KINGMAN CREEK PLANT - ANNUAL AND DUNE INSPECTION

KINGMAN STEAM PLANT - ANNUAL ASH DIKE INSPECTION

**TRUCKING DAMS PLANT - INVESTIGATION OF A SMALL PARALLEL FLOW THROUGH THE
DAM**

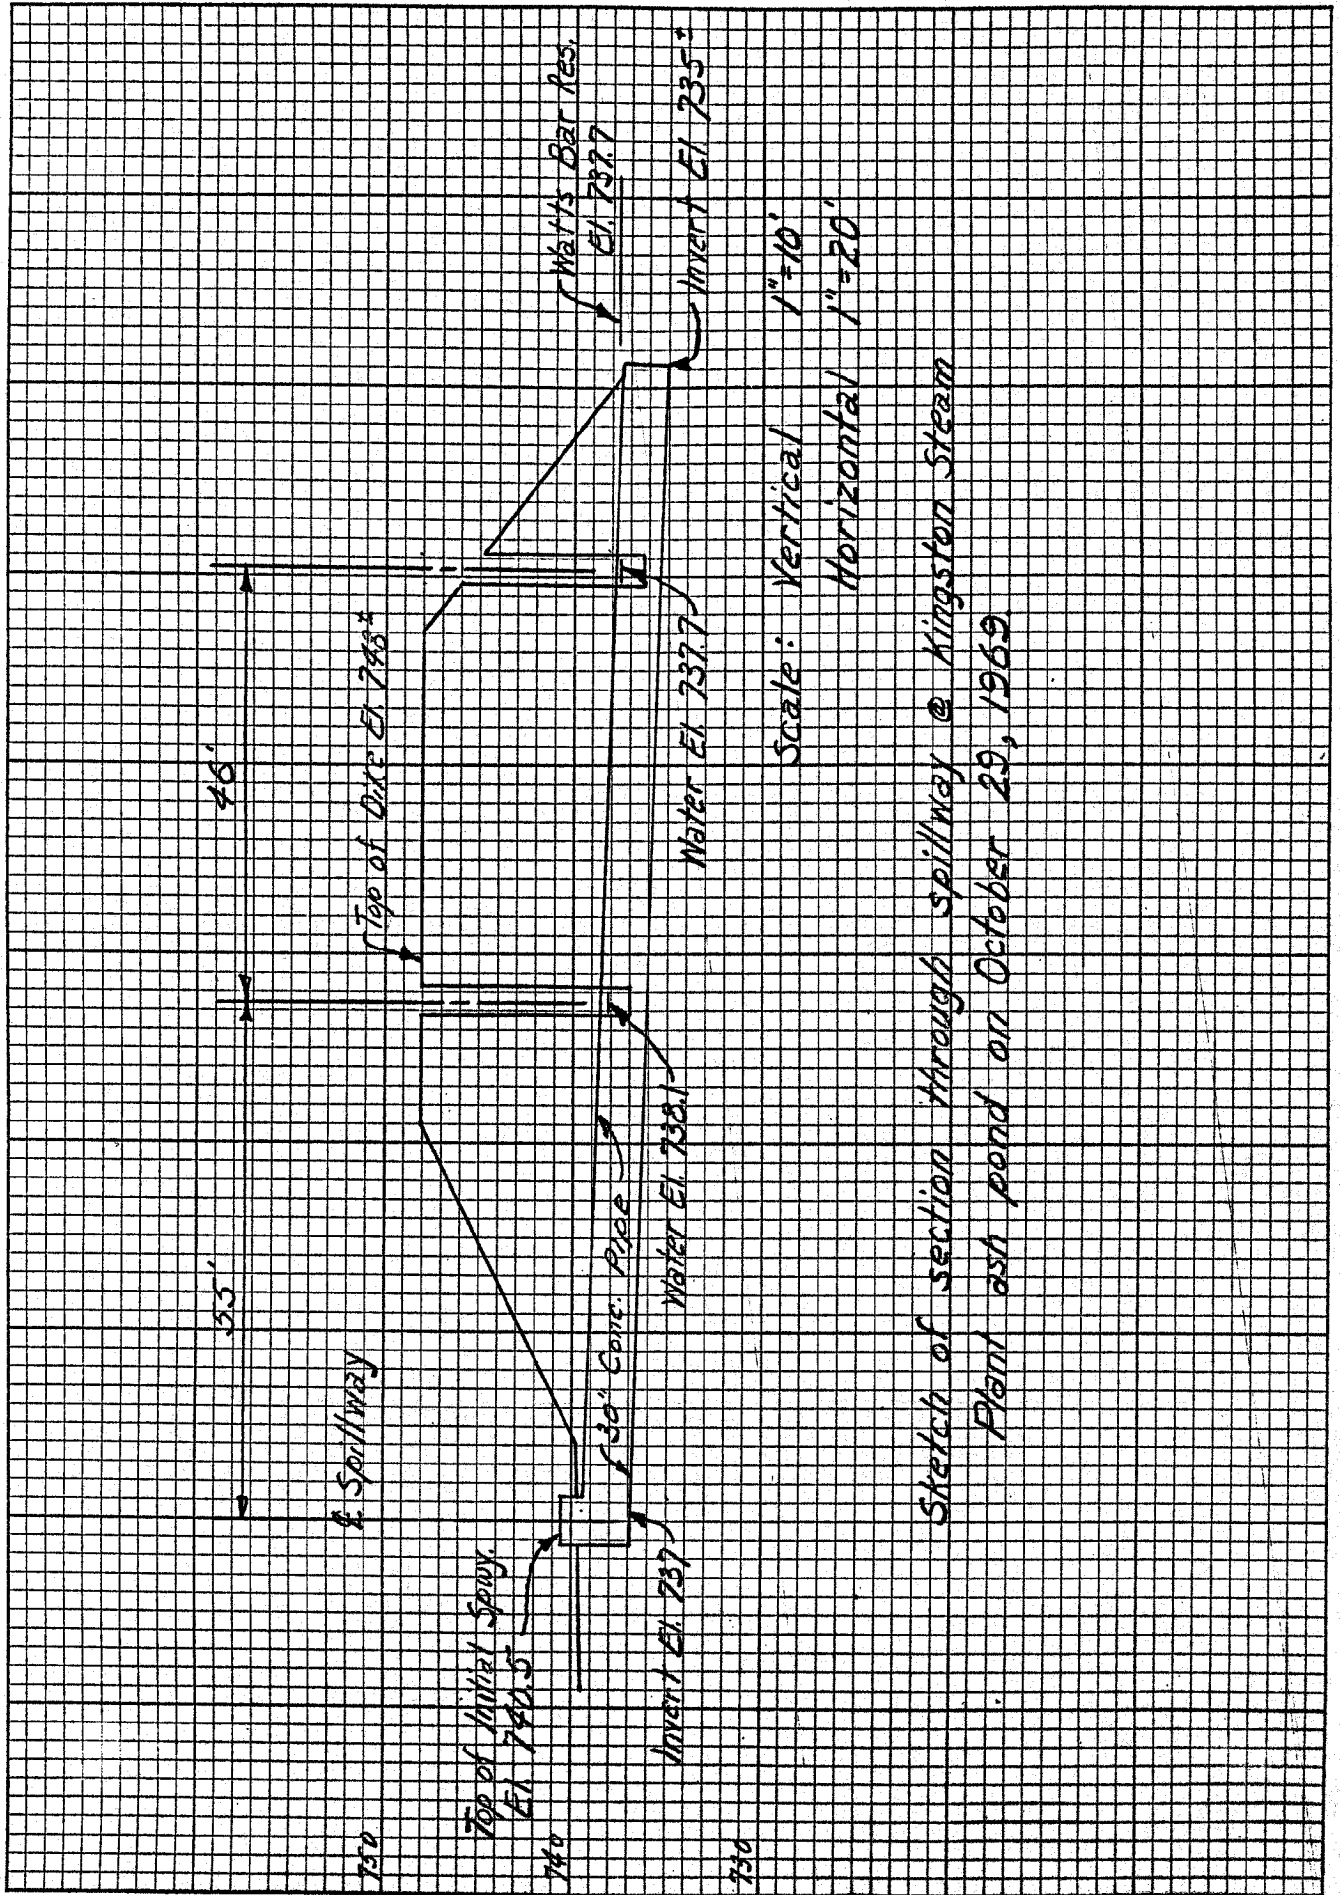
There was considerable flow parallel to the pipe as observed from the previously described observation hole (see attached sketch). This eliminated undermining at the outlet end as a possible cause. In order to learn whether the flow was from water within the pipe or from a parallel channel extending the full length of the pipe, an additional hole was excavated at the edge of the dike road on the pond side. Water which entered this hole was not from a channel parallel to the pipe but seeped slowly from the soil in the bottom of the hole.

Water in the hole nearest the reservoir was at the same level as the reservoir. The water level in the hole on the pond side of the dike road was 0.4 feet higher than the reservoir and 1 foot lower than the pond.

When dye was placed in the spillway, it appeared in the hole nearest the reservoir, but not in the one nearest the pond. This proved

1. Shut out all water from the inlet and outlet ends of the pipe and pump dry. Then pump the hole nearest the reservoir and see if the flow is virtually eliminated (very small seepage of ground water may remain).

2. If the shutting out of water (1) eliminates all but minor ground water seepage, the following will be done:
 - a. Inspect inside of pipe and attempt to locate bad joints.

- b. Excavate fill around pipe from the reservoir hole toward the centerline of dike until the bad joint (or joints) is exposed. (We specified that the ditch should extend no farther than the centerline of the dike road without further inspection by Design but shall be a minimum of 10 feet in length.) Excavation will be made by the buckets until the top half of the pipe is exposed. Additional hand excavation will then be done to expose as much of the lower portion of pipe as practicable so that the buckets can be backfilled with well compacted impervious material. Hand excavation will be done in small longitudinal segments with each segment being back-filled prior to the excavation of the adjacent segment. This will minimize the possibility of the pipe settling due to reduced support during the excavation.

- c. Backfill with selected impervious clay material placed in 4-inch layers and extensively compacted with pneumatic tamper.
 - d. Short pipe from the inside at all bad joints.

| | | ION400 | R4 |

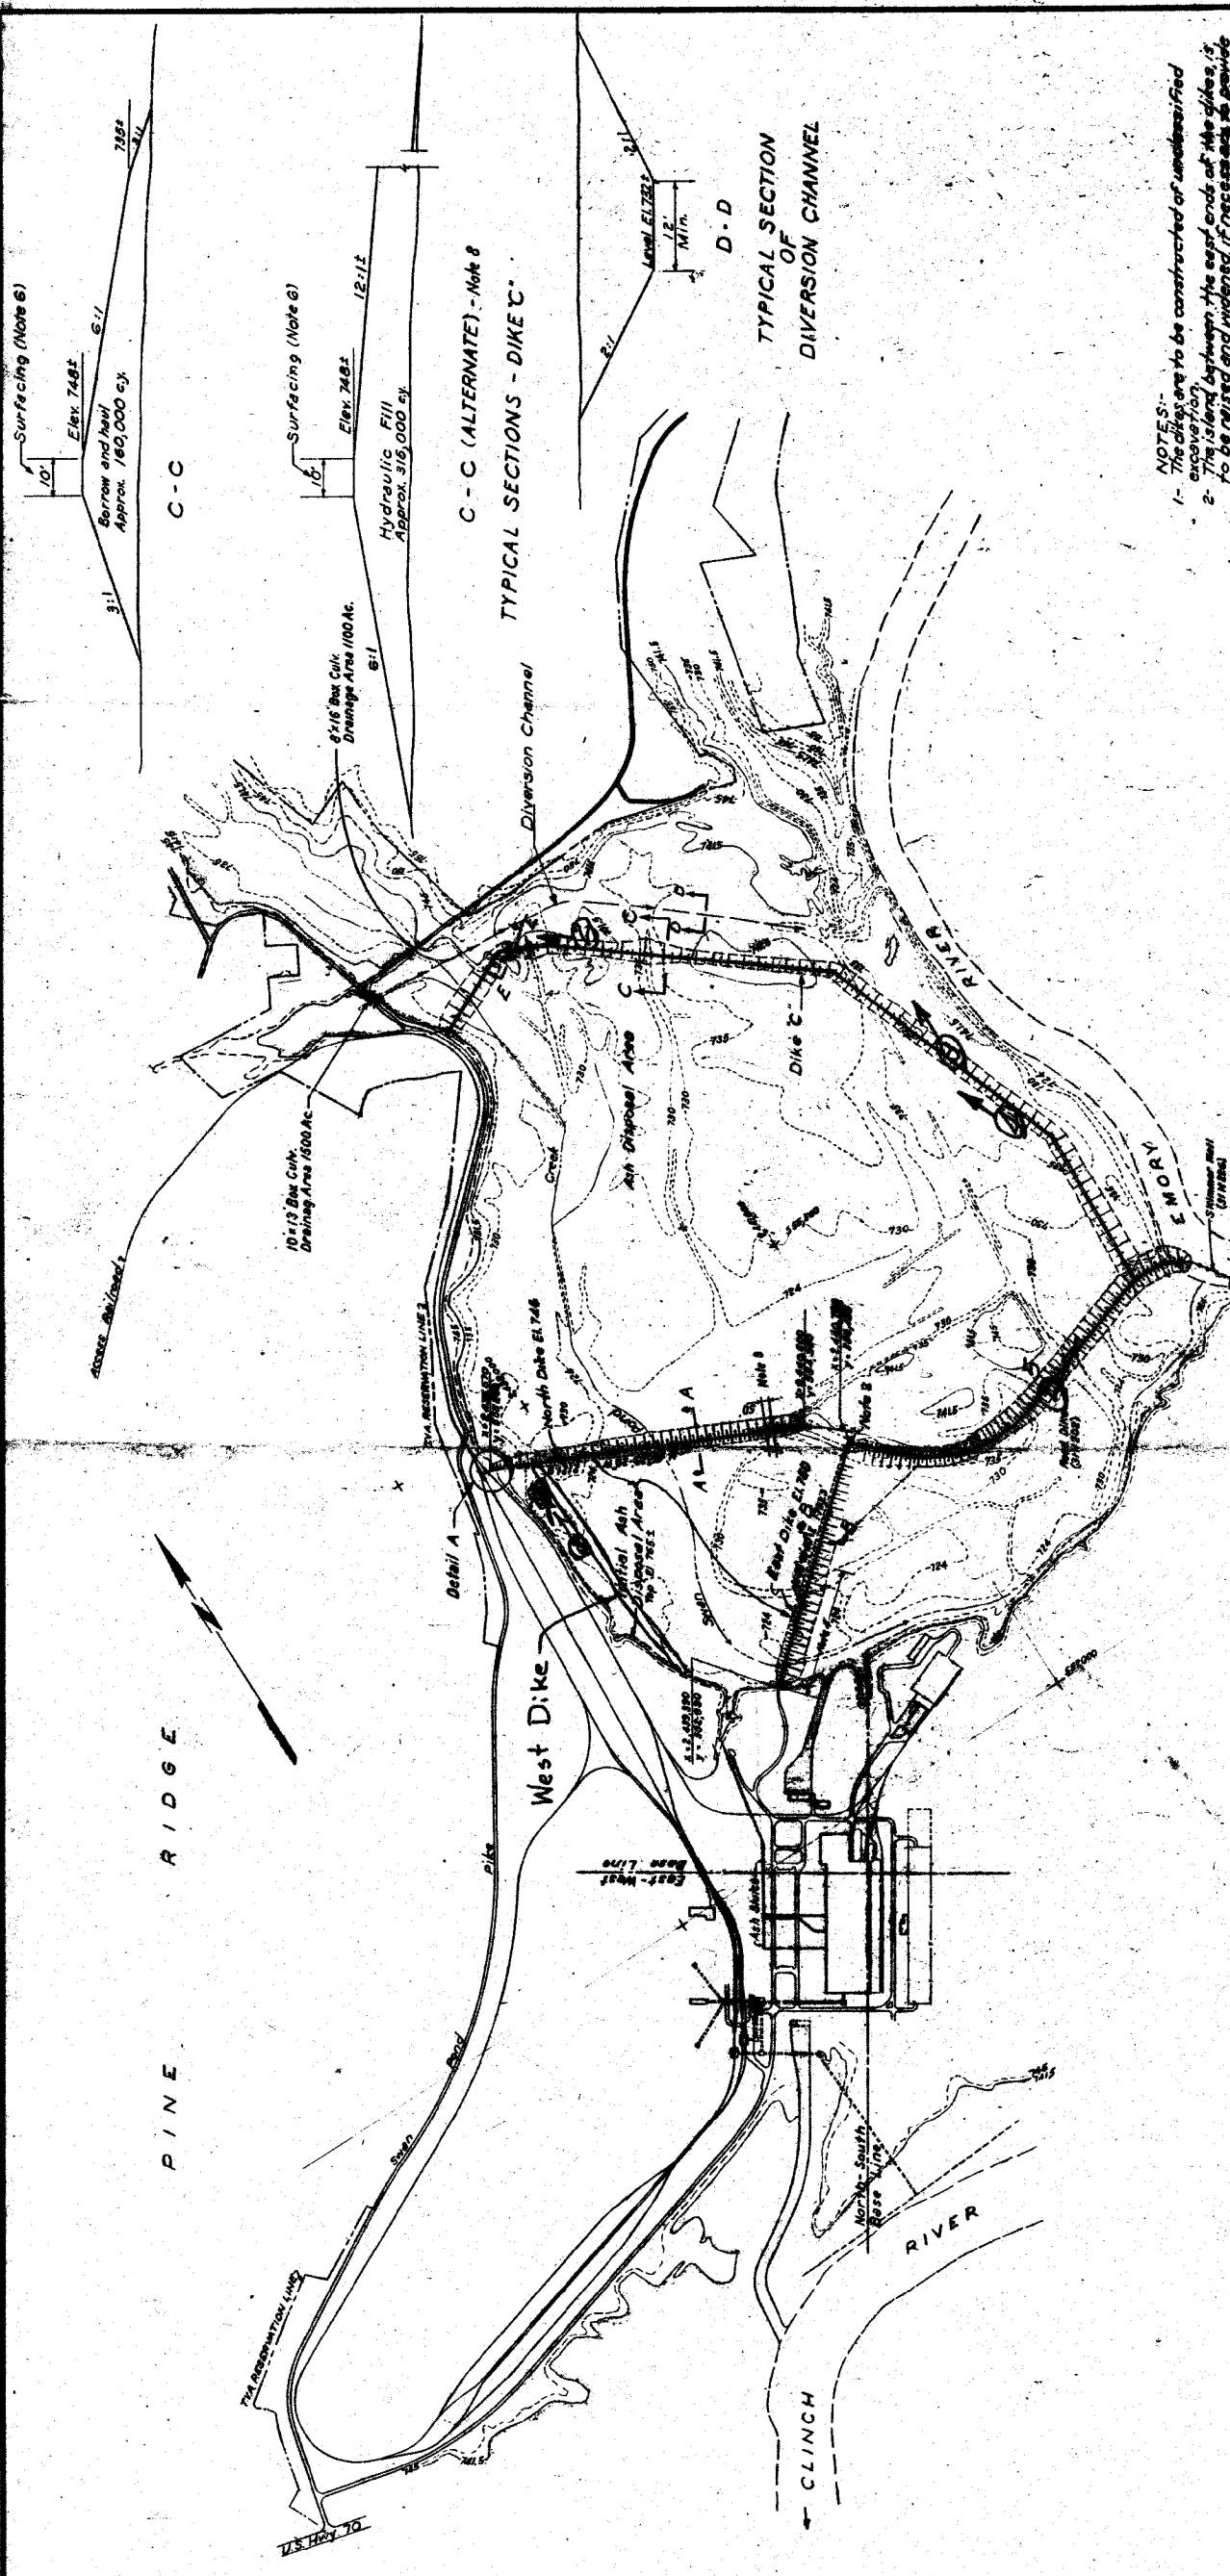
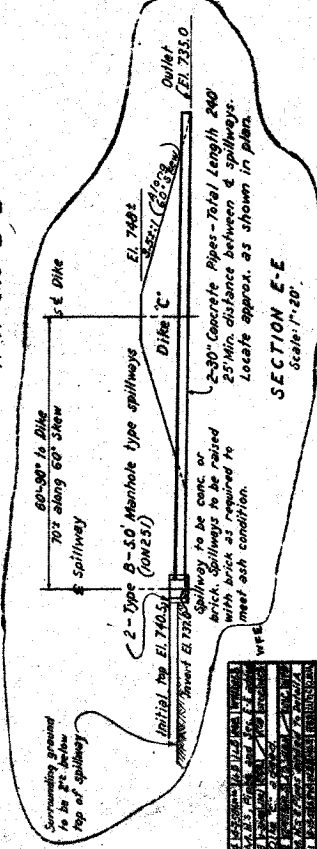
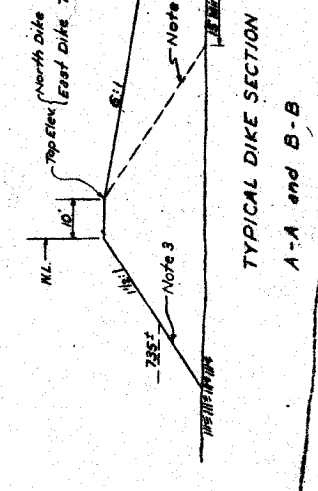
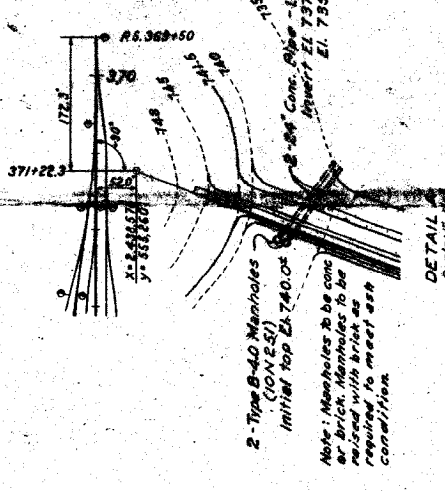
Plant personnel have completed raising the dikes around the initial ash area with heavy ash to approximately elevation 768. The outside slope of the east dike is approximately 6:1 and is in very good condition. The outside slopes of the north and west dikes are approximately 2:1 with the outside slope of the west dike developing some erosion gullies (picture 1). The top width of the dikes is approximately 30 feet. The north dike is having ash deposited against it. The outside slope of the west dike will be flattened. The dikes are named on the attached print of drawing 10N400.

Plant personnel were in the process of widening the road dike to the inside prior to raising (picture 2). See attached print of drawing 10N400 for location of pictures.

1. Dress up the outside slope of the west dike and slope to 3:1, maintaining a top width of at least 16 feet.
2. On the outside slopes of the east and west dikes of the initial area, establish two experimental plots, on each slope, about 50 feet long. One plot shall be covered with 6+ inches of soil fertilized and seeded; the other plot shall be lined to neutralize the ash, then fertilized and seeded. We recommend type 7 grass mixture for seeding. Seeding and fertilizing shall be in accordance with section 100 of the T-1 Specifications. Design shall be notified of the results of these experiments.

4. Continue widening the existing dikes before raising. The top of the original dikes shall be left as a berm and the dikes raised with slopes of 2:1 on the inside and 3:1 on the outside with 16-foot top width. The maximum height of each lift shall not exceed 10 feet before providing a berm.
